Davis-Besse Nuclear Power Station  
5501 North State Route 2  
Oak Harbor, Ohio 43449-9760

Subject: Response to Requests for Additional Information Concerning the Davis-Besse Nuclear  
Power Station Third Ten-Year Interval Inservice Inspection Program

Response to Request for Additional Information Concerning  
The Davis-Besse Nuclear Power Station Third Ten-Year Interval  
Inservice Inspection Program

FIGURE NUMBER: BO1.040.0524.1

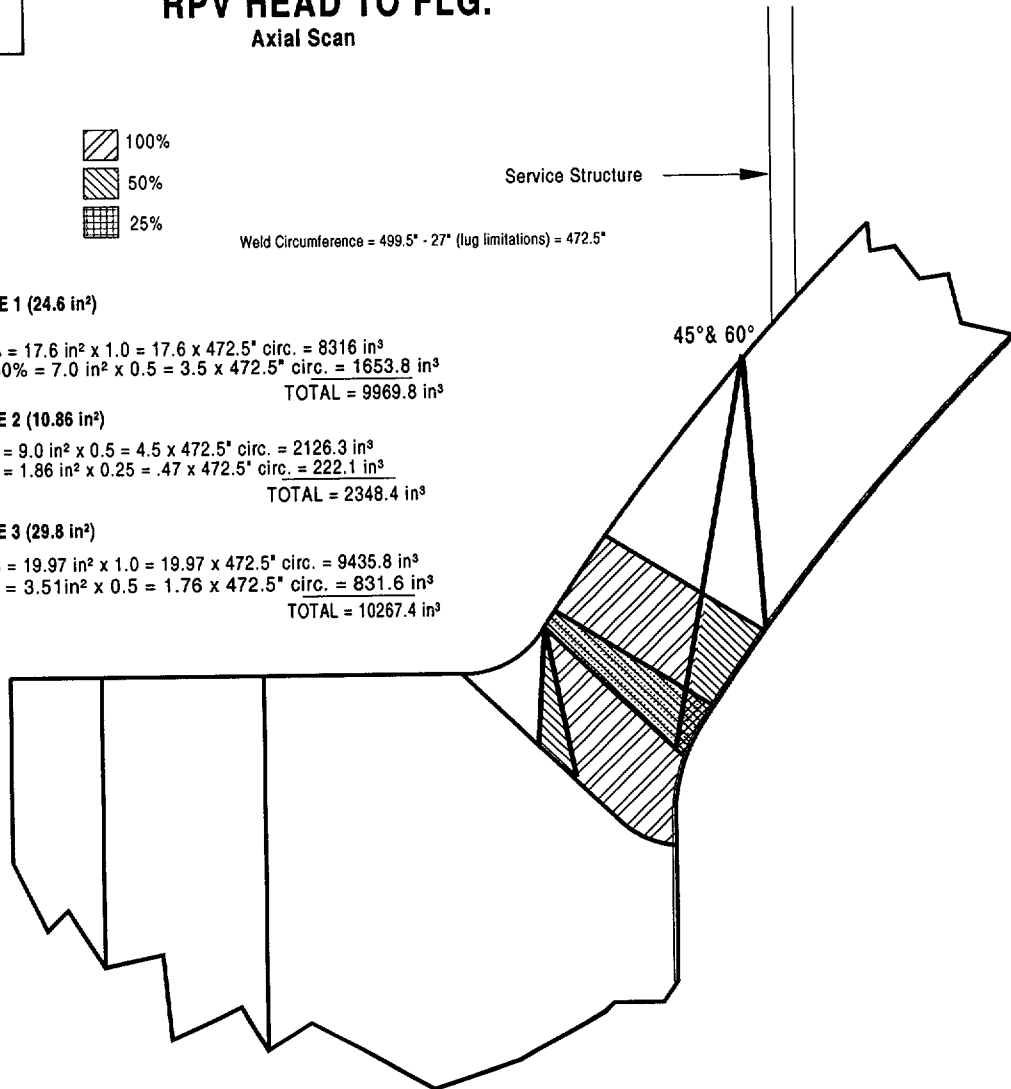
been proved to be capable of detecting flaws in the Head-to-Flange weld. In order for the proposed alternative to be acceptable, please provide the following:

- (1) The licensee has discussed design limitations that involve the transition curvature of the head base material relative to the flange and the positioning of the three lifting lugs as the main reasons for requesting relief from the Code required volumetric examination. The licensee states that because of these limitations, approximately 80% of the weld will be examined volumetrically. Provide drawings or sketches to illustrate these limitations. Also, provide drawing ISI-SK-002 which has been referenced in the basis section.

1. A scaled cross sectional drawing of the component configuration, extent of coverage and the area of interest is drawn using a Computer Aided Design Drafting (CADD) program. The examination area is divided into 3 zones. Zones 1 and 3 are the base material on either side of the weld. Zone 2 is the weld material.

3. The examination coverage (i.e., the amount of the sound beam that passes through each zone) is plotted on the CADD drawing for each of the ASME Code required scans. The area covered in each zone by the axial, circumferential, and straight beam examinations is then measured by CADD. If the area covered received all the required scans, it is considered 100 percent complete. If it received one-half of the required scans, it is considered 50 percent complete, etc. This area is then multiplied by the weld length to determine the examination volume covered.

4. The examination volume covered in each zone by the axial, circumferential, and straight beam scans is multiplied by the weighting factor. After applying a weighting to each scan, they are added together and divided by the total area for that zone to determine the percent complete for the zone. Then all the 3 zones are added together and divided by 3 to determine the total examination coverage.
5. When the total examination coverage is less than 90 percent, additional angles, such as 70 degrees and 35 degrees are plotted to determine if they will increase the examination coverage. Based on this determination and the principals of ALARA, additional scans beyond those required by the ASME Code are performed to increase examination coverage when considered necessary.

# DH Cooler 1-1 Weld G

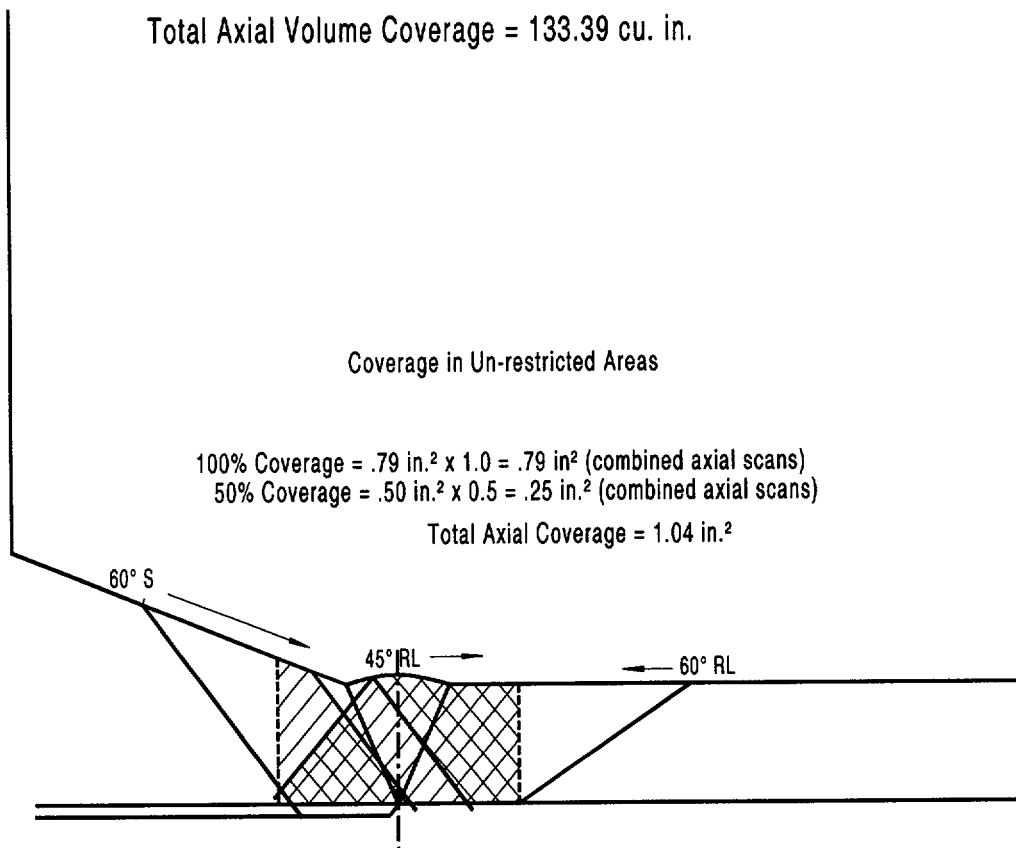
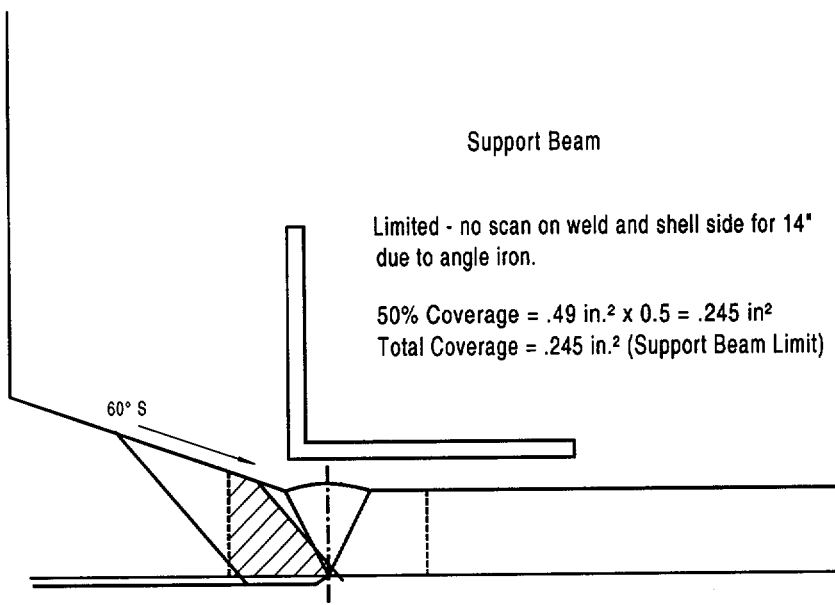
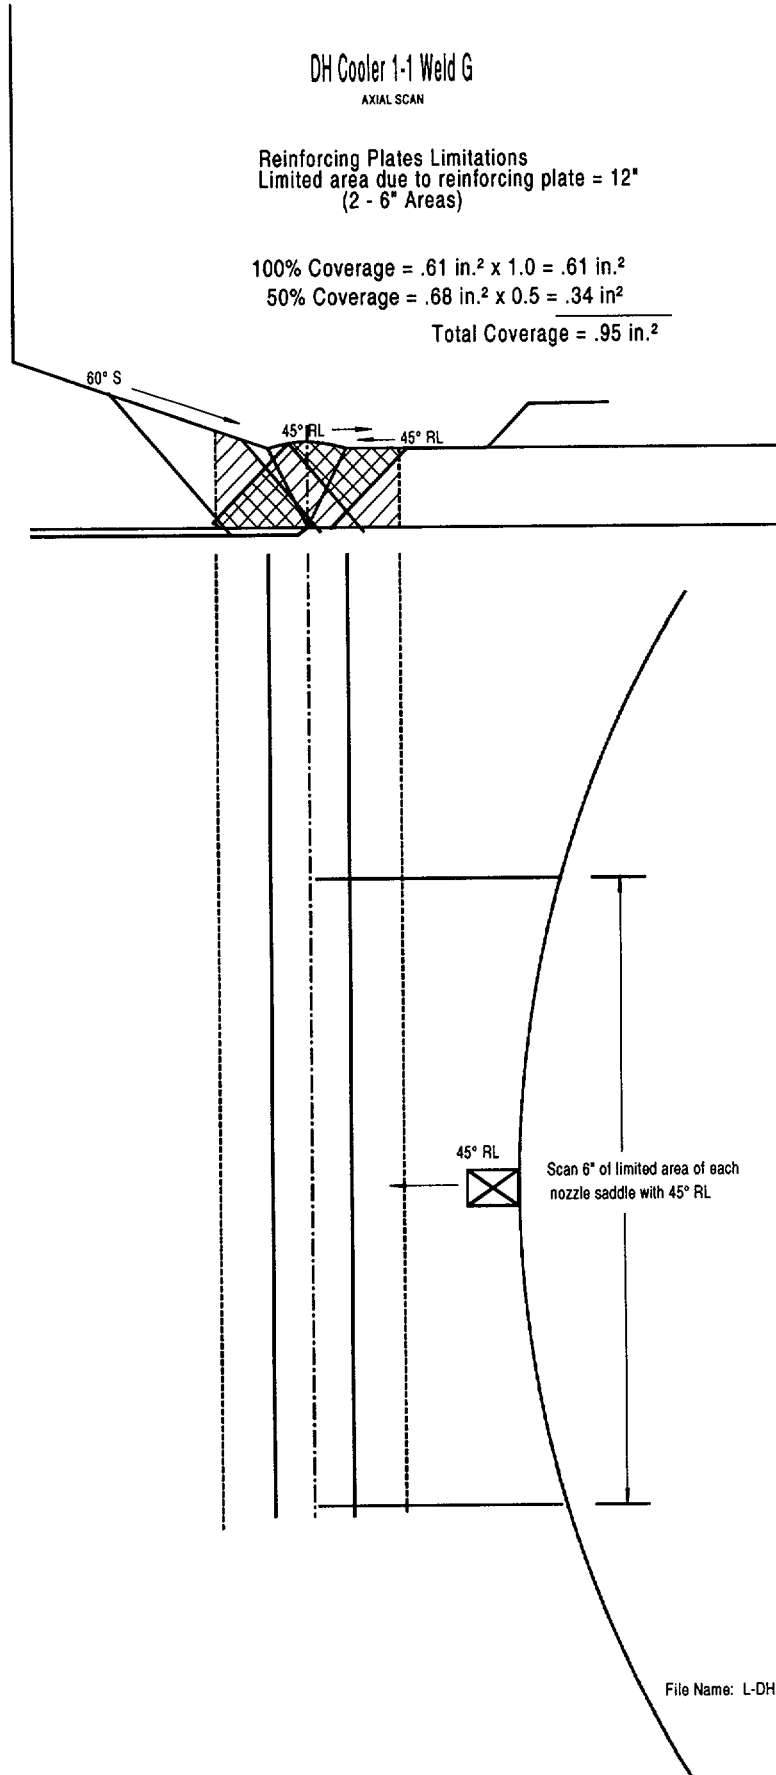
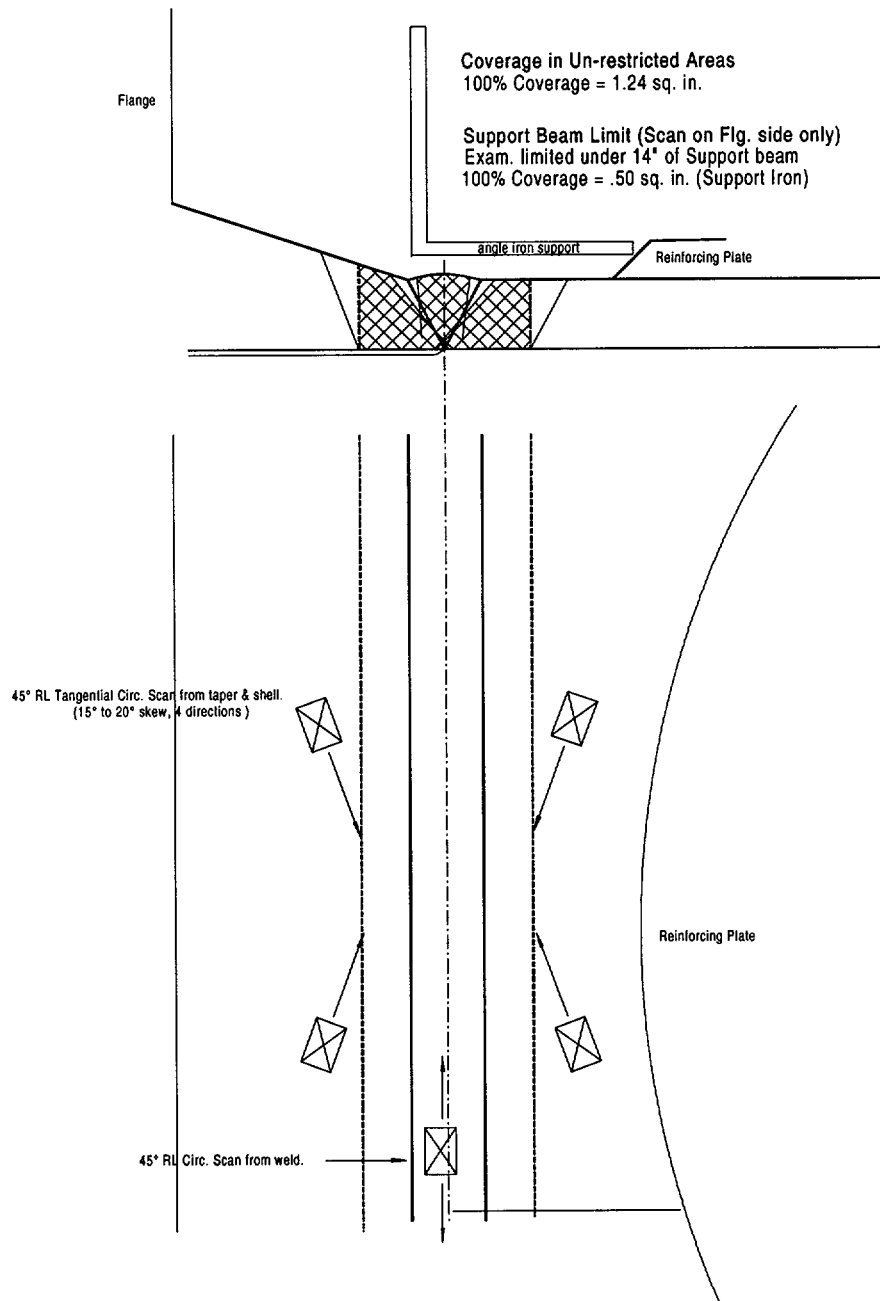
The proposed alternative examination, in conjunction with the surface examination of the reinforcing plates, has been proved to be capable of detecting flaws in the shell-to-flange welds. In order for the proposed alternative to be acceptable, please provide the following:

- (1) Illustrate with sketches and/or drawings how the specific shell-to-flange weld configurations interfere with the nearby components and limit the examination coverages.
- (2) Provide Drawing ISI-SK-050 showing the Weld G, as indicated in the Code Requirement section of the relief request.

1. A scaled cross sectional sketch of the component configuration and the examination volume is drawn using a Computer Aided Design Drafting (CADD) program.
2. Each weld requires 4 scan directions (2 axial and 2 circumferential in opposing directions). Each scan provides 25% of the total examination coverage.
3. The ultrasonic beam paths are overlaid on the drawing. The area of coverage is measured using the CADD program for each scan direction.
4. The volume of coverage for each scan is calculated by multiplying the area of coverage by the length of the weld. This volume is then multiplied by 0.25 (25%) as each scan represents 25% of the total required scans. The products for each scan are added together to determine the combined volume scanned.
5. The combined volume is divided by the total volume of the weld and multiplied by 100. This is the percent of examination completed.

Reinforcing Plates Limitations  
Limited area due to reinforcing plate = 12"  
(2 - 6" Areas)

Weld Circumference = 140"  
 Total Area = 1.33 sq. in.  
 Coverage under Support = 14" x .5 sq. in. = 7 cu. in.  
 Coverage of remaining weld = 126" x 1.24 = 156 cu. in.  
 Total Circ. Coverage = 163 cu. in. (unrestricted + limited areas)
